SUBJECT: ISSUANCE OF AMENDMENT (TAC NO. 72997)

The Commission has issued the enclosed Amendment No. 39 to Facility Operating License No. NPF-49 for Millstone Nuclear Power Station, Unit No. 3, in response to your application dated April 20, 1989.

MILLSTONE NUCLEAR POWER STATION, UNIT NO. 3

AMENDMENT TO FACILITY OPERATING LICENSE

Figure 3.9-1

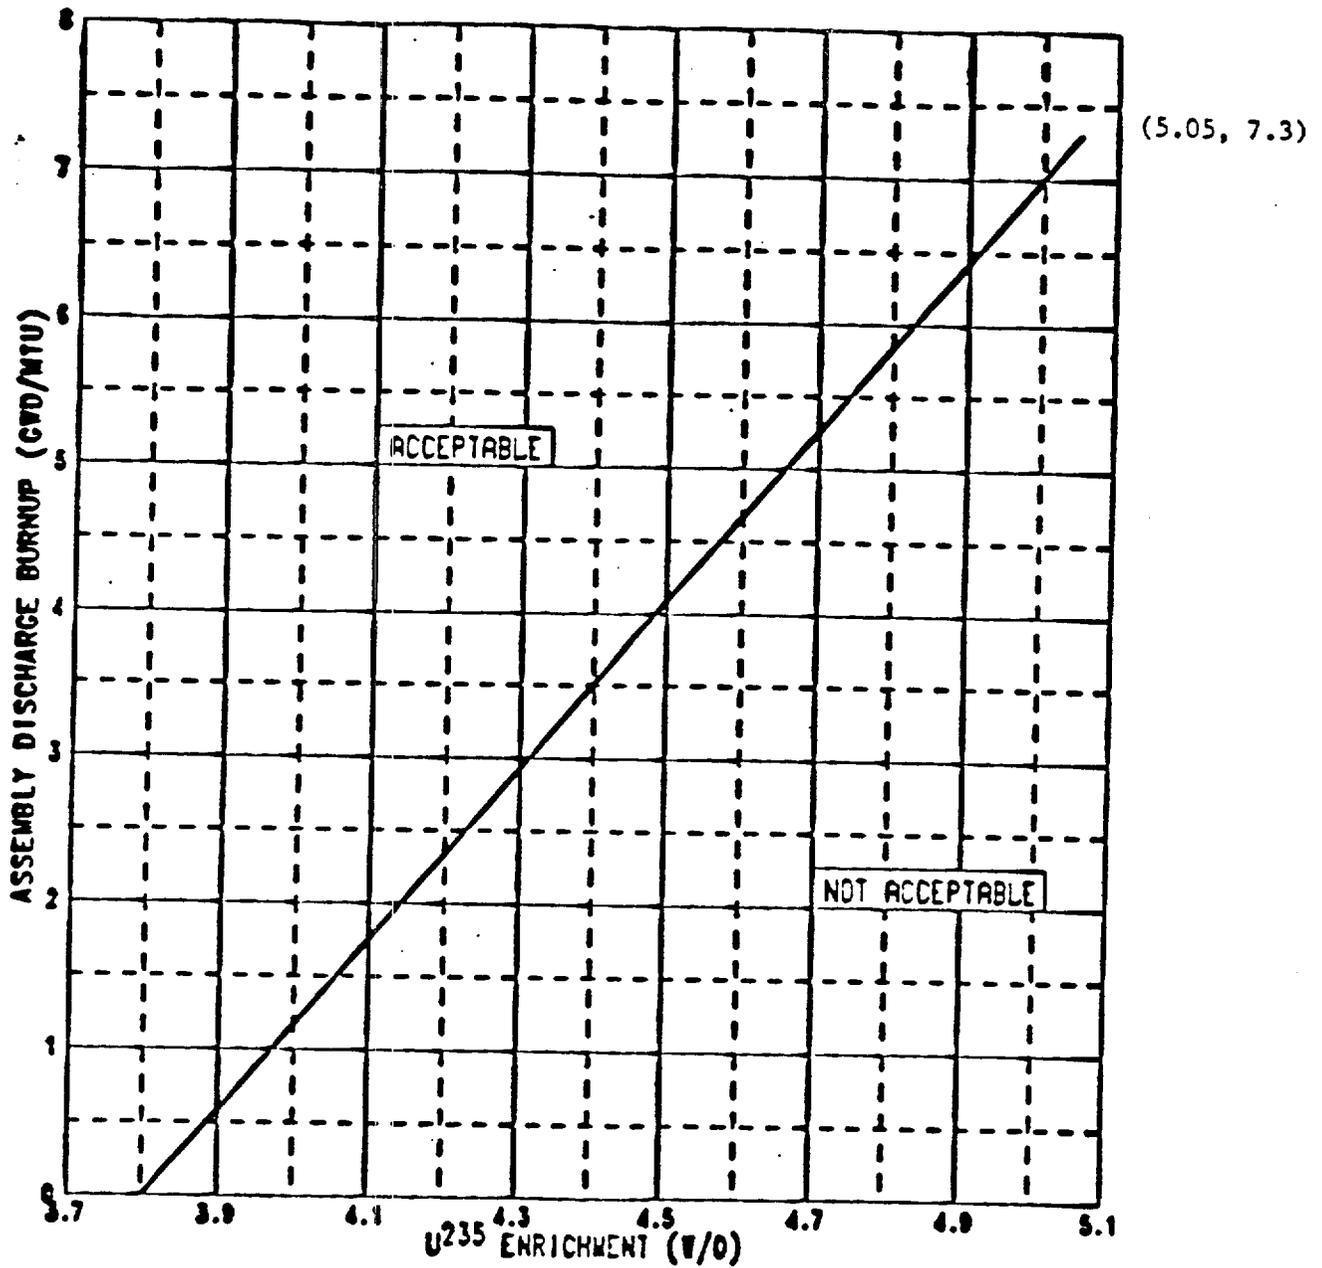
4.9.13 Ensure that all fuel assemblies to be placed in Region II of the spent fuel pool are within the enrichment and burn-up limits of Figure 3.9-1 by checking the fuel assembly's design and burn-up documentation.

The limitations described by Figure 3.9-1 ensure that the reactivity of fuel assemblies introduced into Region II are conservatively within the assumptions of the safety analysis.

- d. Fuel assemblies stored in Region II of the spent fuel pool may have a maximum nominal fuel enrichment of up to 5.0 weight percent, conditional upon compliance with Figure 3.9-1 to ensure that the design burnup of the fuel has been sustained.

Figure 3.9-2

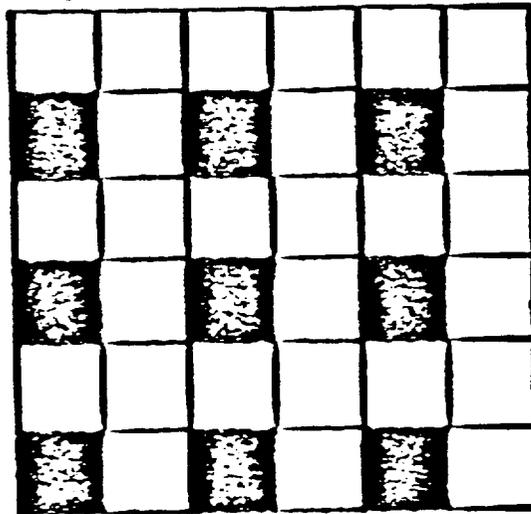
- a. Prior to storing fuel assemblies in the STORAGE PATTERN per Figure 3.9-2, the cell blocking device for the cell location must be installed.
- b. Prior to removal of a cell blocking device from the cell location per Figure 3.9-2, the STORAGE PATTERN must be vacant of all stored fuel assemblies.

STORAGE PATTERN for the Region I storage racks will be established and expanded from the walls of the spent fuel pool per Figure 3.9-2 to ensure definition and control of the Region I/Region II boundary and minimize the number of boundaries where a fuel misplacement incident can occur.

- c. Fuel assemblies stored in Region I of the spent fuel pool may have a maximum nominal fuel enrichment of up to 5.0 weight percent U_{235} . Region I is designed to permit storage of fuel in a 3-out-of-4 array with the 4th storage location blocked as shown in Figure 3.9-2.
